Service-Information Motorcycle

34 011 86
(2230)

Squealing from Drum Brakes - R65's, R80's - 1985 and Later, and K75's

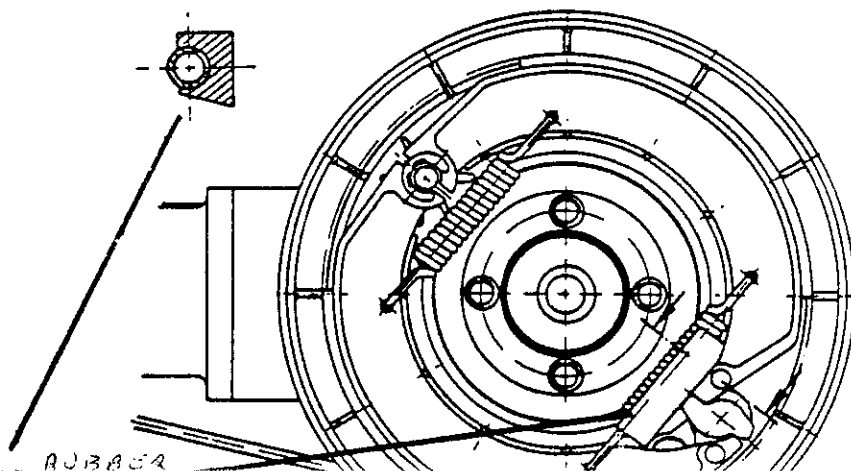
Squealing noise from rear drum brake when brake is applied.

The squeal is caused by the return spring vibrating. Depending on the intensity of the vibration, this squeal can be annoying.

Installation of a dampening rubber around the brake spring at the Brake Shoe Pivot will dampen the vibration and the squeal noise will be minimized.

The rubber damper is installed only onto the rear brake shoe return spring. The flat side of the rubber rests against the brake shoe and pivot cam, with the slanted side facing the rear wheel (facing the left).

When installing this rubber damper, also change both brake springs.
